Determination 2022/003

Regarding the compliance of proposed alterations to a dwelling by way of Acceptable Solutions B1/AS1 and E2/AS3

118A Melrose Road, Mt Roskill, Auckland

Figure 1: Basement Floor Plan with floor levels and new retaining walls (not to scale)

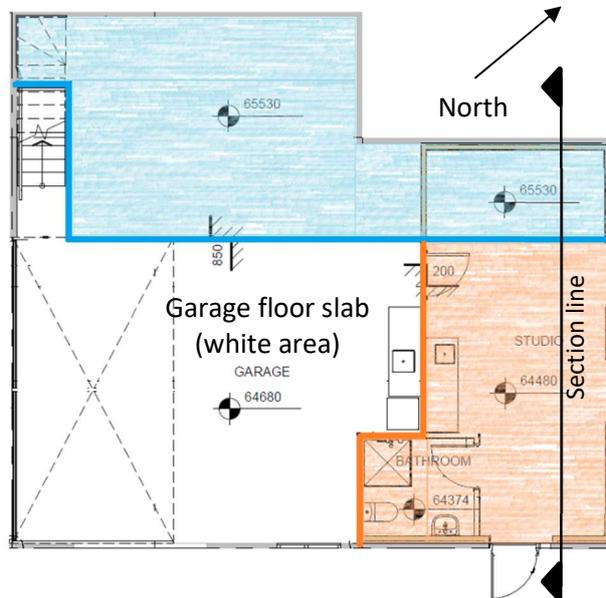
- 2.3.1. Item 1 - a 100mm thick concrete floor slab for the studio, reinforced with 10mm diameter ('D10') 300MPa⁵ reinforcing bars distributed within the slab at 300mm spacings (also referred to as 'centres') in both directions with 'grade E' seismic rated bars ('300E').

- 2.4. In September 2021, the authority requested further information to enable it to process the building consent application. The request stated that the concrete floor slab “shall be provided with reinforcement as per B1/AS1, [paragraph] 2.0 Masonry; 2.1.1, NZS 4229, Clause 7.8.3”, as the owner’s proposed method of reinforcement using reinforcing steel bars was “not acceptable”

- 2.5. The authority also advised the owner that it would not accept the damp-proof membrane as the waterproofing for the back of the retaining wall. According to the owner, the authority instead required the waterproofing to be designed in accordance with CCANZ CP 01:2014⁸ (‘Code of Practice for Weathertight Concrete and Concrete Masonry Construction’). This required using a tanking membrane⁹ on the back of the wall, with a cavity between the back of the wall and the natural ground beyond to be backfilled with filtration gravel.

6.1.1. The proposed reinforcing of a concrete slab floor with reinforcing bars (Item 1) does not comply with Building Code Clause B1 by way of paragraph 2.1.1 Acceptable Solution B1/AS1.

6.1.2. The proposed waterproofing of a masonry block retaining wall and a timber framed retaining wall using a damp-proof membrane (Item 2) does not comply with Building Code Clause E2 by way of Acceptable Solution E2/AS3.

Figure 2: Section 1 (not to scale)

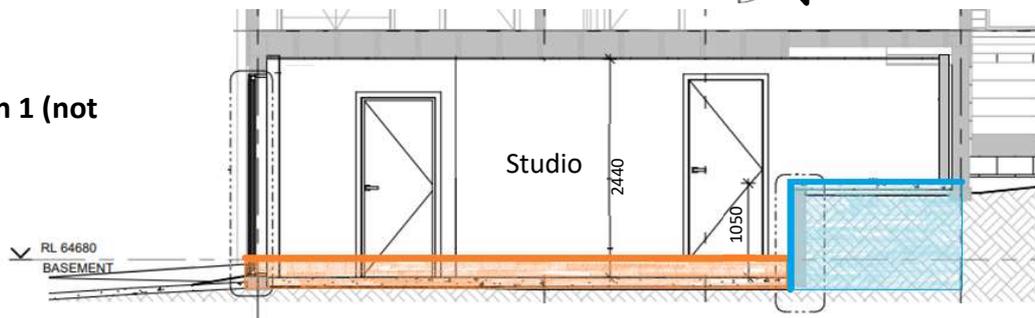
2.3.2. Item 2 – two retaining walls that both form part of the walls for the new proposed habitable space/studio; a concrete masonry block retaining wall (refer Figure 1, indicated as the Blue line) of varying height between 850mm to 1050mm high and a 300mm high timber framed retaining wall⁶ (refer Figure 1, indicated as the Orange line), to be waterproofed using a ‘damp-proof membrane’⁷.

- 4.27. I note NZS 4229 only provides for concrete masonry retaining walls. The timber framed retaining wall, by virtue of the use of timber, is not within the scope of NZS 4229. I therefore disagree with the owner's view that the timber framed retaining wall complies with NZS 4229. Furthermore, there are no Acceptable Solutions in respect of Clause E2 that provide for the waterproofing of timber framed retaining walls that form habitable space²⁰. Accordingly, the timber retaining wall does not comply with any Acceptable Solution for Clause E2 External moisture. I now turn to the concrete masonry retaining wall.
